Product Change Notification

PCN-ICC-9685-2024

The entire cable duct portfolio and its supply chain are being strategically optimized in terms of design, packaging, resilience and sustainability.

Previous Product	New Product
Old version	New version
 Cable duct side punching & marking	 Cable duct side punching & marking
 Cover	 Cover
 CD-WR	 CD-WR

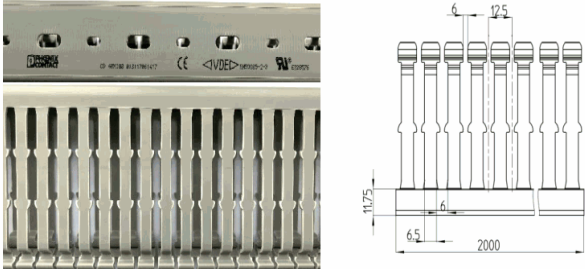
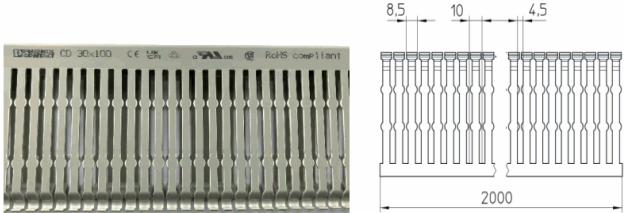
1. The redesign of the "fingers" and it's predetermined breaking point allows the user to remove them in a more controlled manner. The outer dimensions, the color, and the technical properties of the duct remain unchanged. Thus, mixing of the old and new versions is possible, however, the covers of the old and new designs are NOT interchangeable.
2. Packaging quantities are partially adjusted to reduce the packaging variance. Furthermore, the switch to a neutral, non-printed packaging will reduce the product environment footprint.
